JRPP No	2011SYW044
DA Number	DA0110/11
Local Government Area	Ku-ring-gai Council
Proposed Development	Demolition of existing dwellings and construction of two residential flat buildings comprising 43 units, landscaping and associated works.
Street Address	6A & 8 Buckingham Road Killara
Applicant/Owner	Aleksandar Design Group Pty Ltd / Urban Peninsula Pty Ltd, Mrs C A M Grundy, Mr J T L Gilroy and Mrs F M Gilroy
Number of Submissions	10 – original DA 12 – amended proposal
Recommendation	Refusal
Report by	Jonathan Goodwill, Executive Assessment Officer

SUMMARY SHEET

REPORT TITLE:	6A & 8 Buckingham Road, Killara
LOT & DP:	Lot 100 DP 1164166 (2-6 Buckingham Road) Lot 3 & 4 DP 414101 (6A Buckingham Road) Lot 1 DP 414101 (8 Buckingham Road)
PROPOSAL:	Demolition of existing dwellings and construction of two residential flat buildings comprising 43 units, landscaping and associated works.
DEVELOPMENT APPLICATION:	DA0110/11
WARD:	Gordon
APPLICANT:	Aleksandar Design Group Pty Ltd
OWNER:	<ul style="list-style-type: none">- 2-6 Buckingham Road: Urban Peninsula Pty Ltd- 6A Buckingham Road: Mrs C A M Grundy- 8 Buckingham Road: Mr J T L Gilroy and Mrs F M Gilroy
DATE LODGED:	10 March 2011
ESTIM

4.3 Setbacks

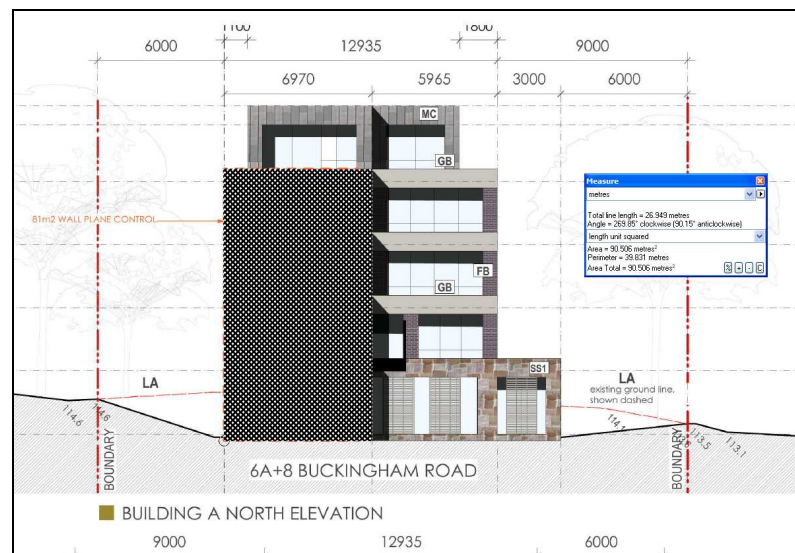
The proposal does not comply with the following control:

- C-1(a) Side and rear boundary setbacks: 6m

As per design control No. 3, the required setbacks extend both above and below ground and apply to all built elements of the development including car parking. Accordingly, the underground connection to Nos. 2-6 Buckingham
